SEWAGE DISPOSAL SYSTEM

HOWARD COUNTY HEALTH DEPARTMENT

SUBDIVISION Pembroke Knolls LOT 1 ROAD 6874 Sanner Road

REPAIR - PURPOSE - SEPTIC SYSTEM HAS FAILED.

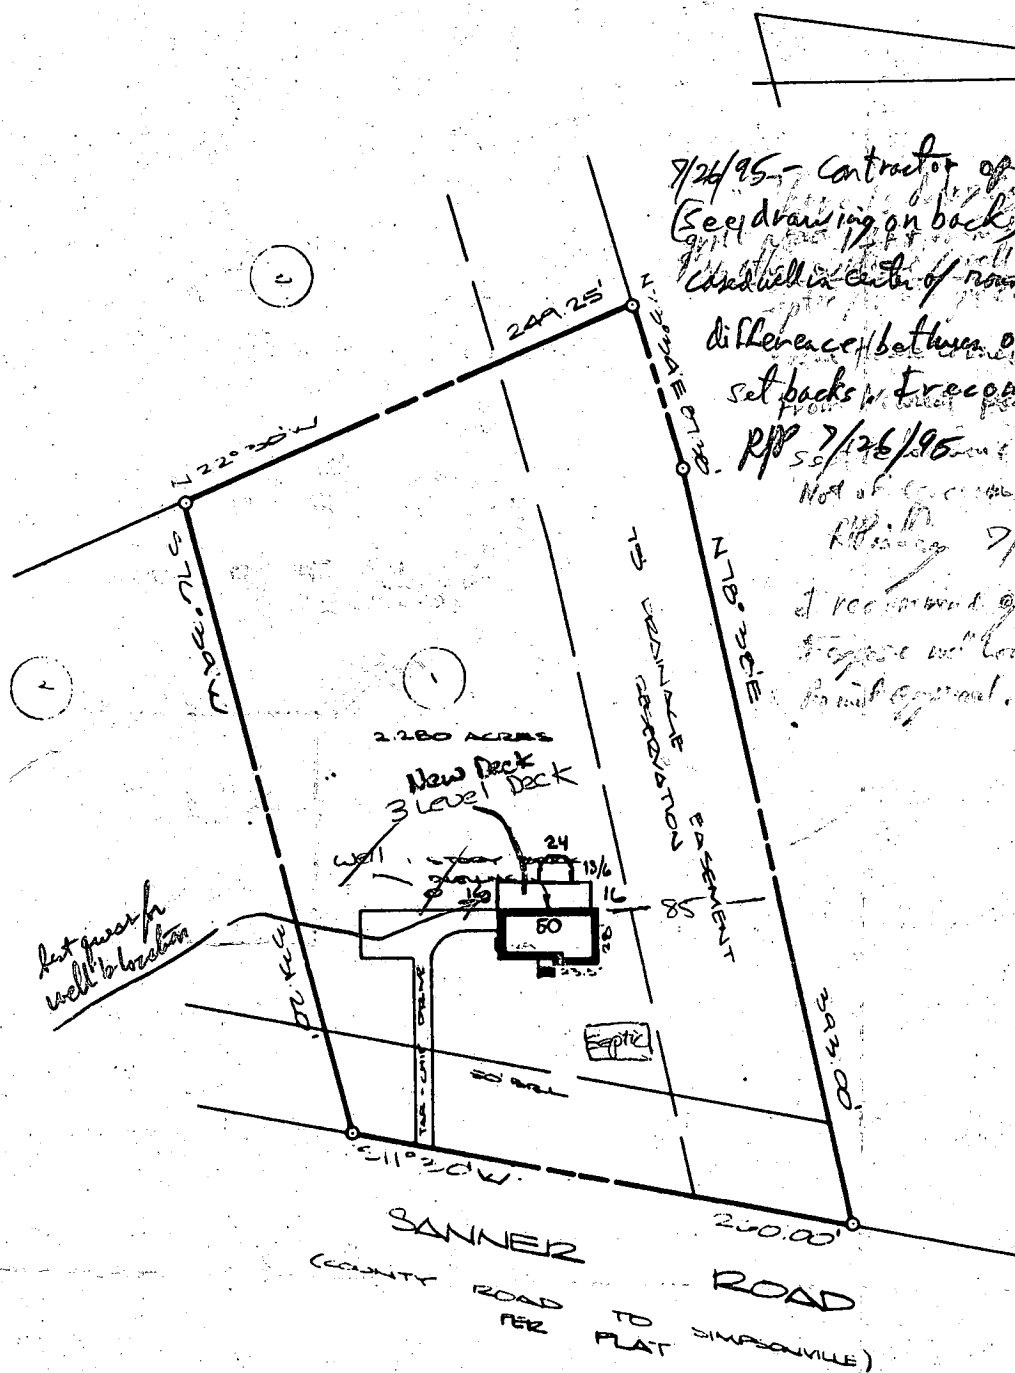
Call for inspection when ground is opened so sanitarian can recommend repair. 08/18/93

SEPTIC TANK LEVEL Existing CLEANOUTS Existing (D.W. C.O. To be completed)

DISTRIBUTION BOX LEVEL 1/4" (coming off old dry well)

DRAIN FIELD/TITLE DEPTH 10 FT. TRENCH WIDTH 2 FT. INLET DEPTH 2 1/2 FT.

EFFECTIVE GRAVEL DEPTH 7 1/2 FT. TOTAL LENGTH 46' + 33' = 79'

NUMBER OF TRENCHES 2 ONE SIDEWALL/BOTTOM AREA 593 SQ. FT. (Plus old system)

REMARKS: 8/25 Partial - ok to continue #1 trench and to dig #2 trench; 8/25 OK TO COVER AS FINISH - Material - On Site - FINAL; CR

PLAT ENTITLED Mr. & Mrs. F. J. Kline

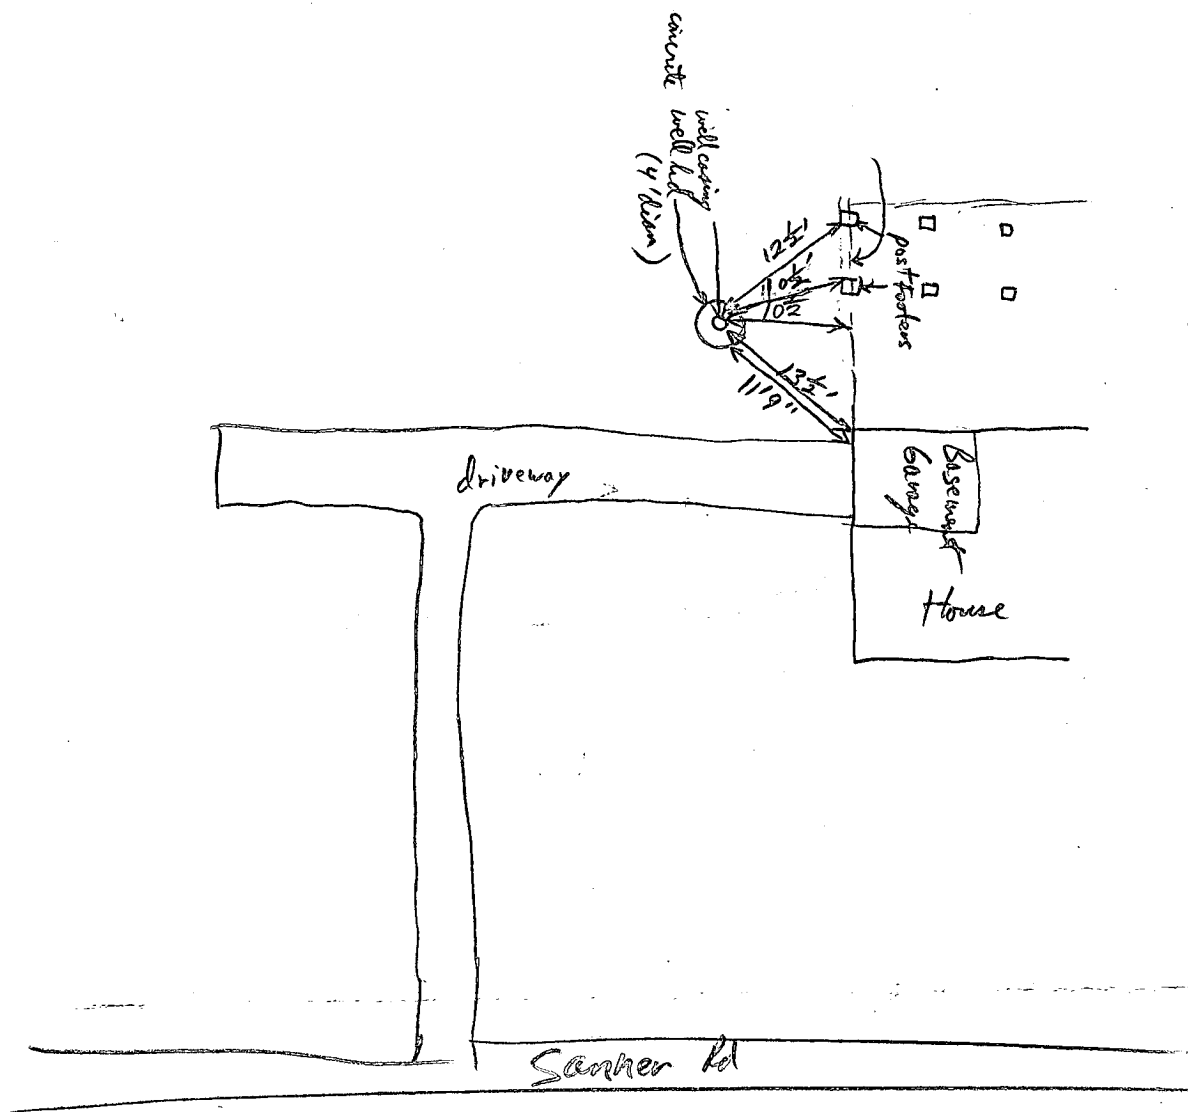
7/24/95 - Contractor opened well pit
(See drawing on back) for dimensions.
Check well in center of round pit. Not fixed
difference between old + New Bldg
set backs. I recommend approval.

I recommend approval
to set well location as per Bldg
Foundation.
